Addendum #: Addendum #4
Issue Date: 04/08/2024

The following additions, clarifications and revisions have been made to the Contract Documents:

Job #: 8-22-01-011 Edgar County Jail
 TBD SPRINGFIELD RD
 PARIS, Illinois 61944

F5 EXTERIOR MEDALLION SIGN

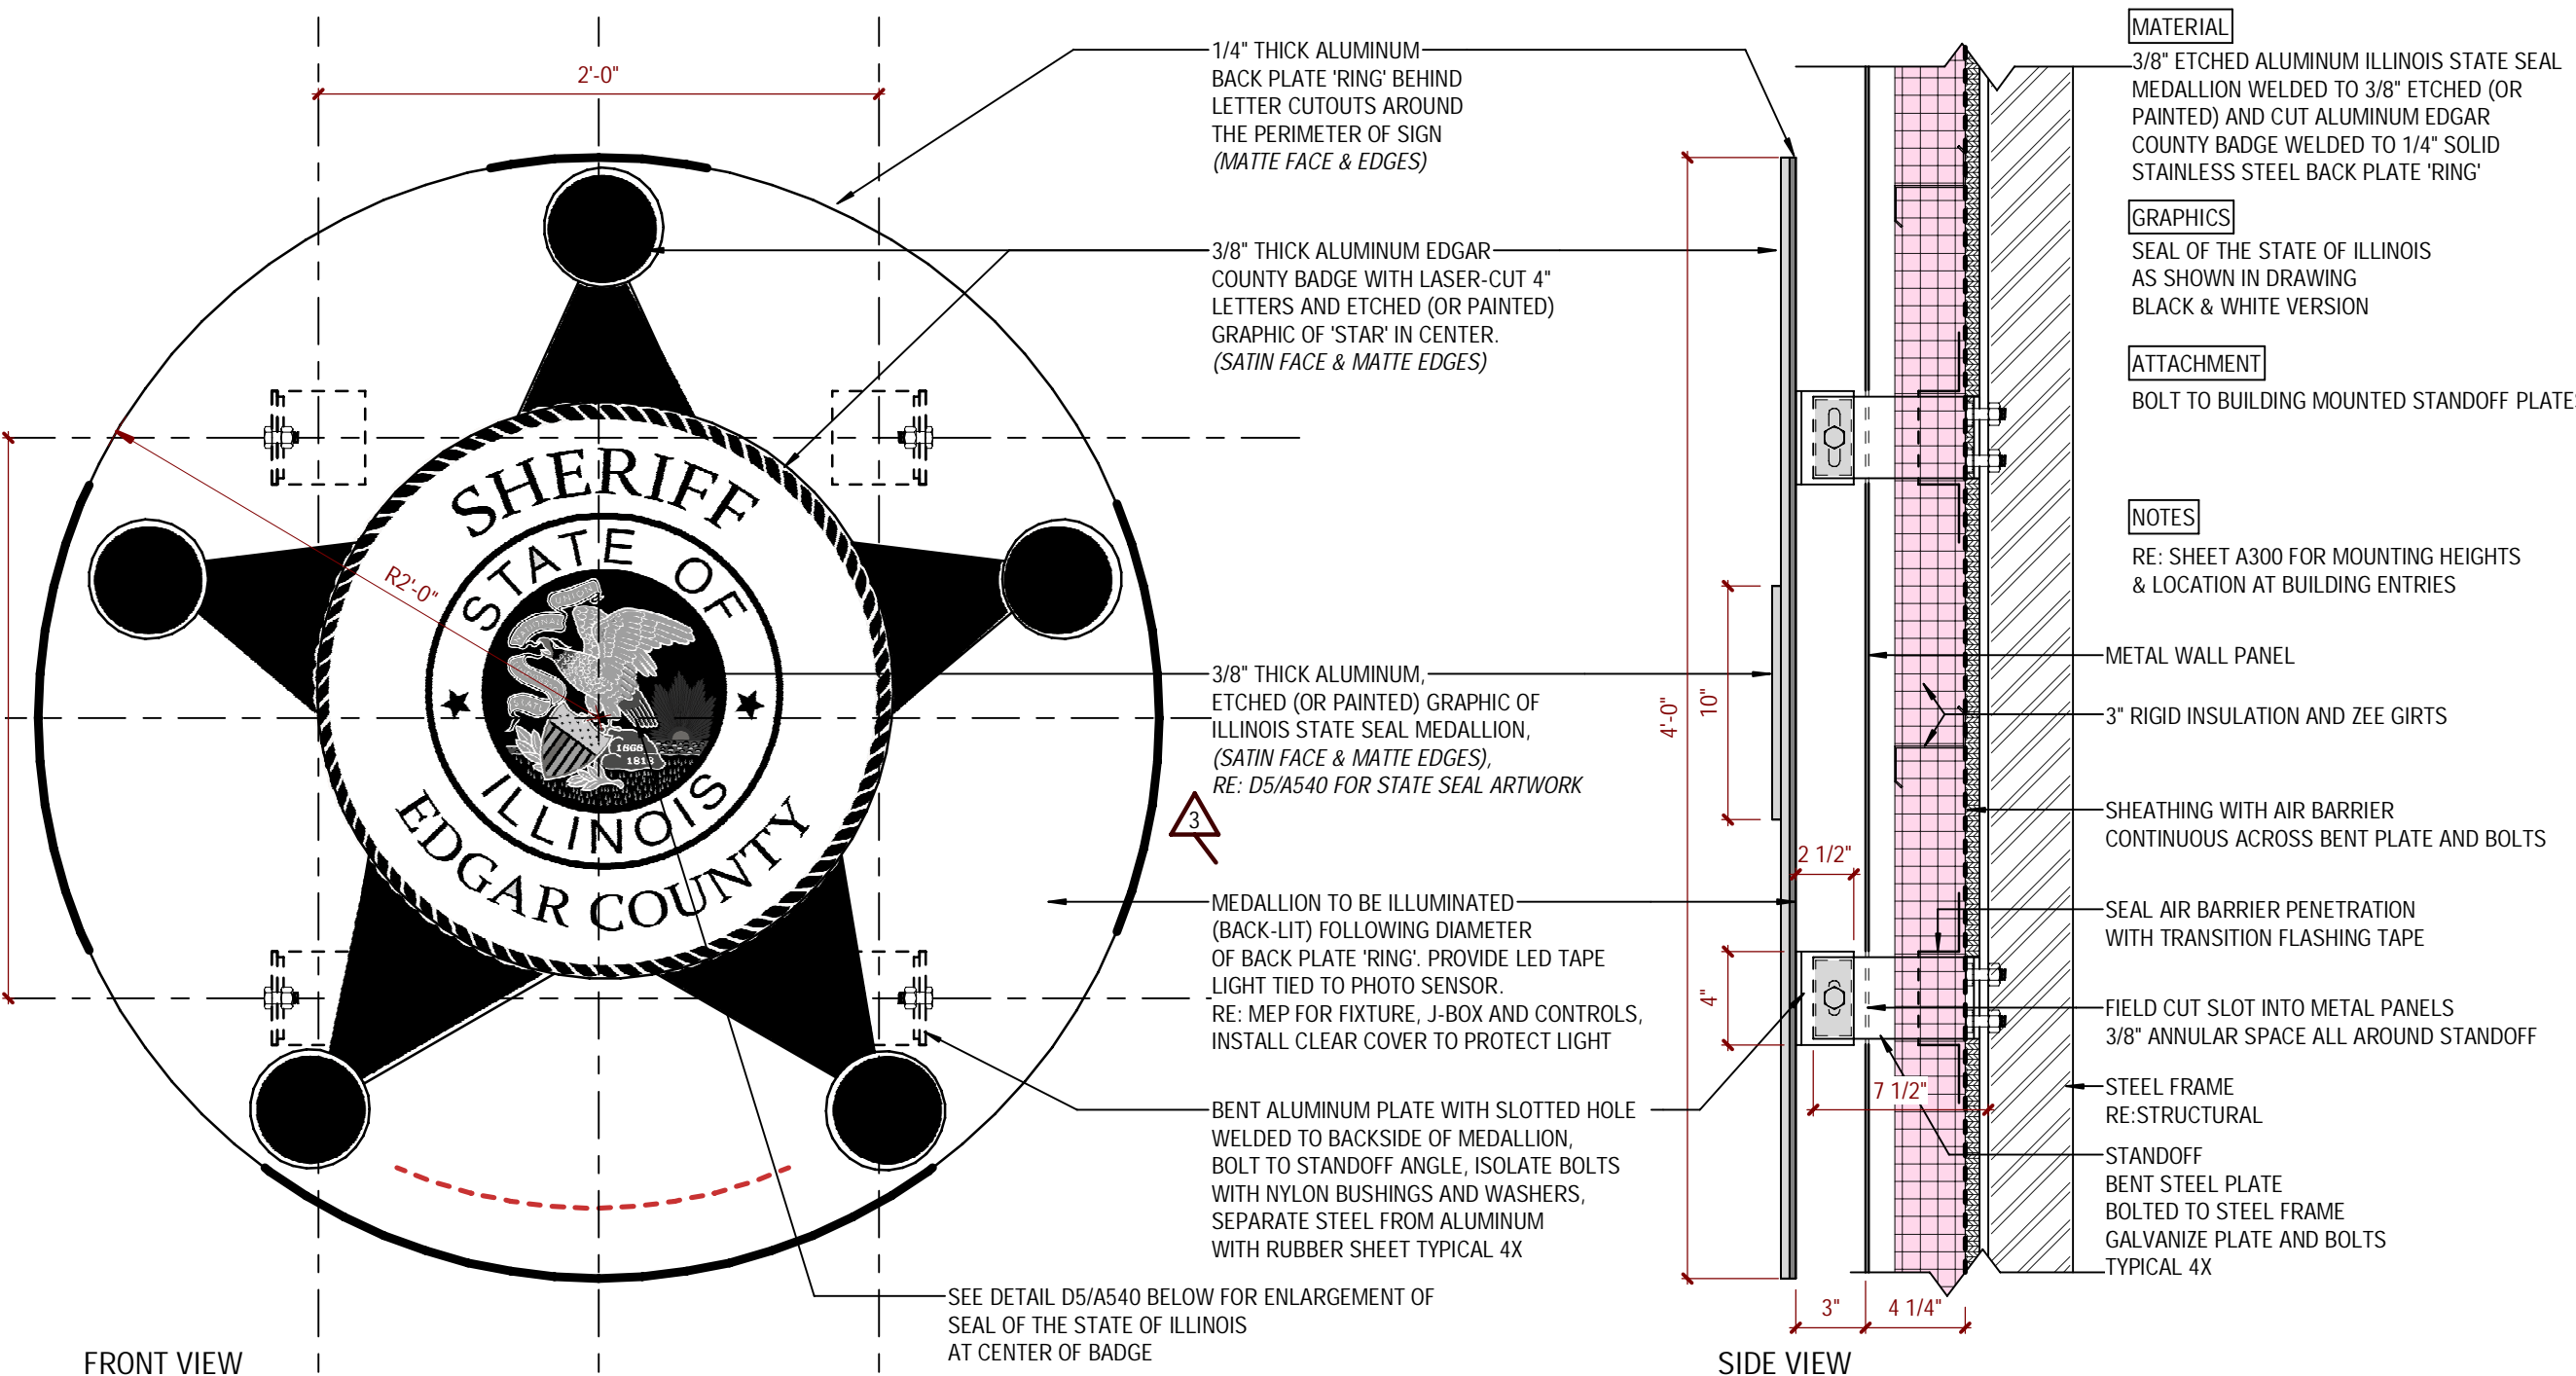
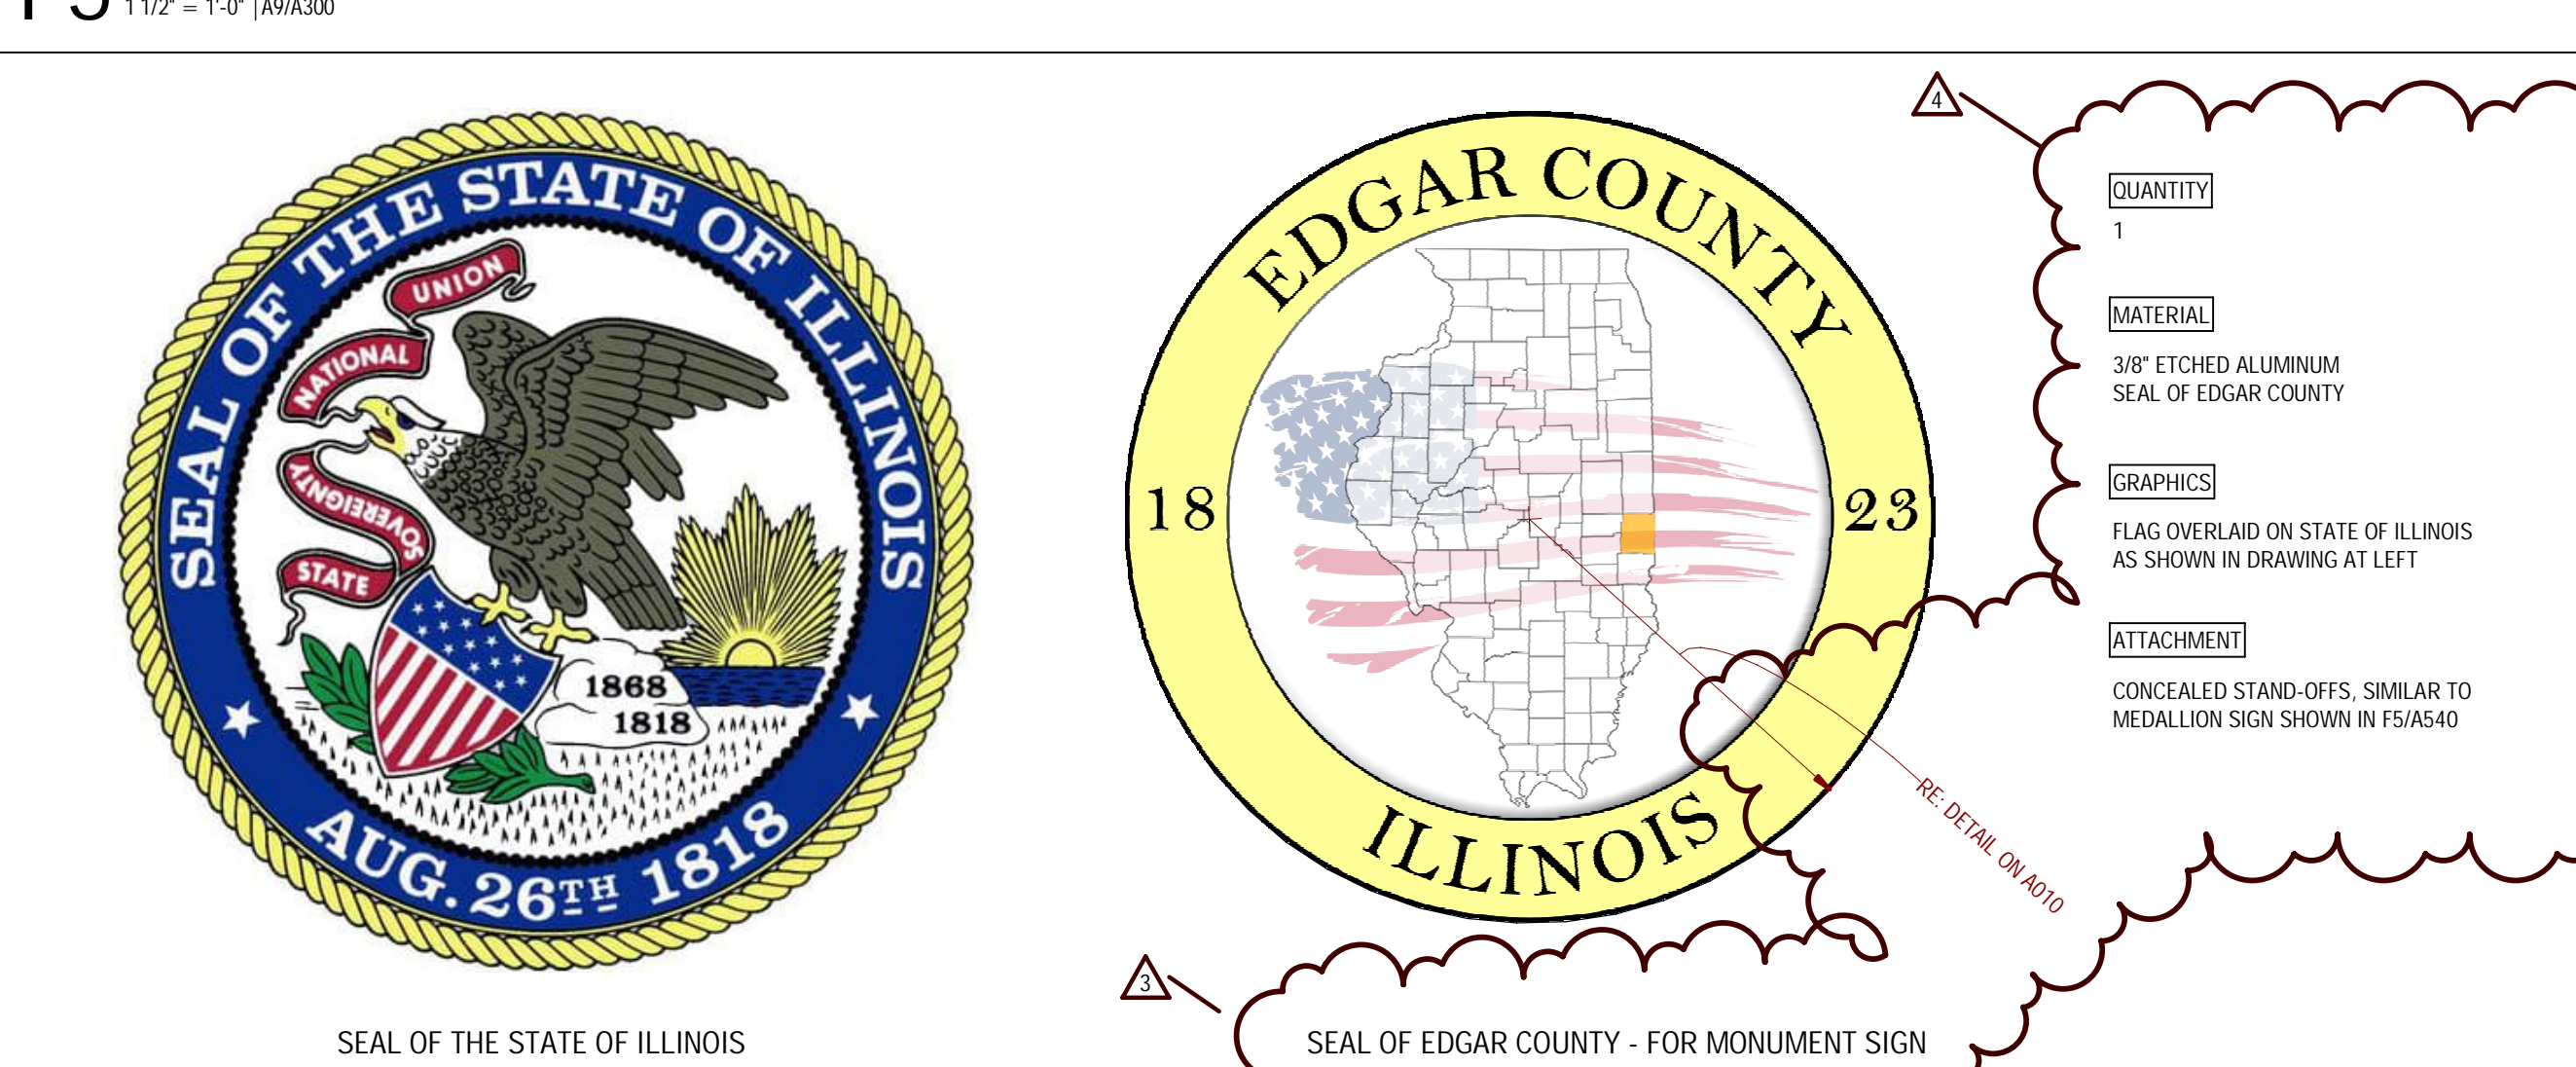
14	A531 Detention Equipment & Interior Details	ADD: Detail D8 to show expansion joint cover at the storm shelter wall.
15	F5/A540 Signage Details	REVISE: Medallion lights will be controlled by light control panel and it can be programmed with photocell. We will add LED tape to Sheet E400 Light Fixture Schedule.
16	A540 Signage Details	REVISE: the quantity listed is for # of characters (i.e. a total count of individual letters) - Sign Type C = 6" tall letters; interior & exterior use = (28) letters/characters total = new info per Addendum 4 to include both interior and exterior signage - Sign Type D = 18" tall letters; exterior use only = (58) letters/characters total
17	A800 Opening Schedule, Door & Frame Types & Window Types	REVISE: On the Opening Schedule (Standard), all exterior hollow metal doors and frames shall be revised from Stainless Steel to hot dipped galvanized. Door #s 153, 157, 158, 163, 164, 169 have been updated in the Opening Schedule (Standard).

SLAB PLAN
 PROJECT NO. 22-4048
 DRAWING ISSUED DATE: 03/01/2024
S102

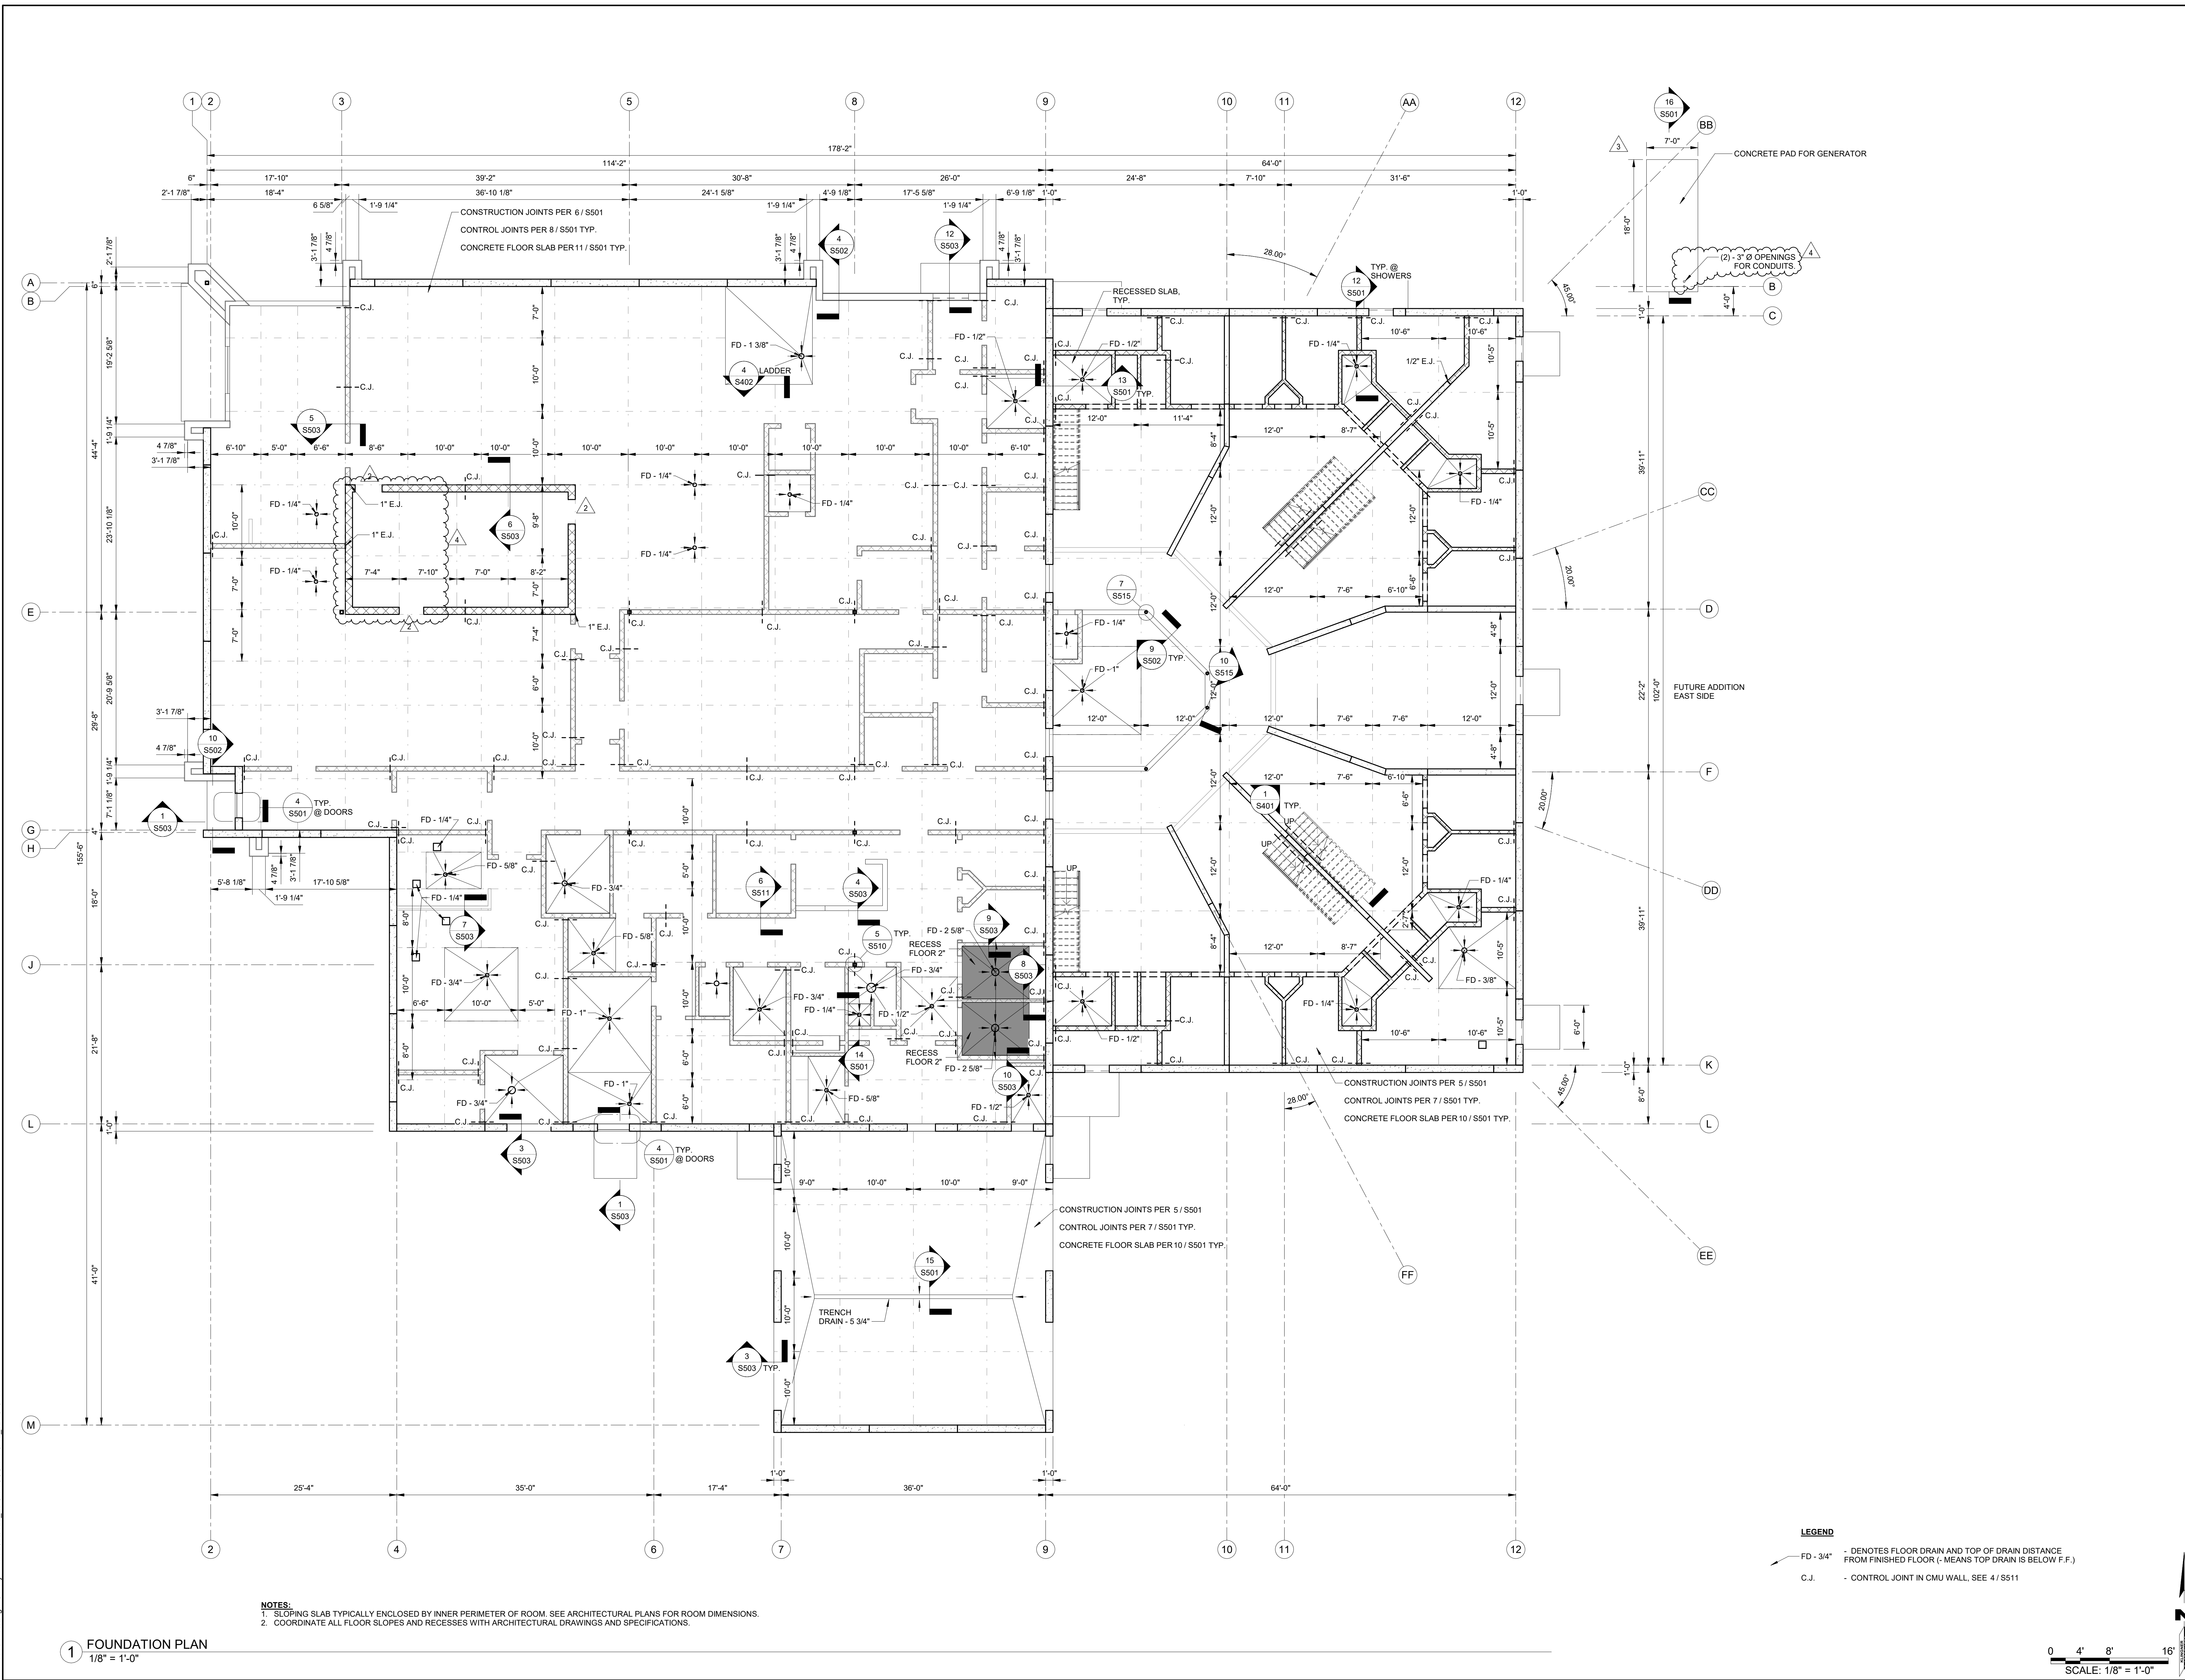
22	S102	REVISED as clouded on Sheet S102
23	S201	REVISED as clouded on Sheet S201
24	S511	REVISED as clouded on Sheet S511
25	S502/S503	CLARIFY: Titles have been revised as shown clouded on the drawing attached to clarify where the details are to be used. The thickened slab footings with top of footings at elevation 100'-0" are intended to be placed with the floor slab, but means and methods of construction will be determined by the Contractor if additional construction joints are necessary. The floor slopes, recessed floors, and drains need to be accommodated as shown on the Architectural, Structural, and/or Plumbing drawings.
26	FP 101 Fire Protection First Floor	CLARIFY: Scope TBD by CM but VESDA system, Detectors, and wiring are all required for proper operation.
27	M101.B HVAC Firest Floor Plan- Area B	CLARIFY: It is acceptable to install the temperature and humidity sensors in the return duct. The setpoints shall be adjustable through the graphics.
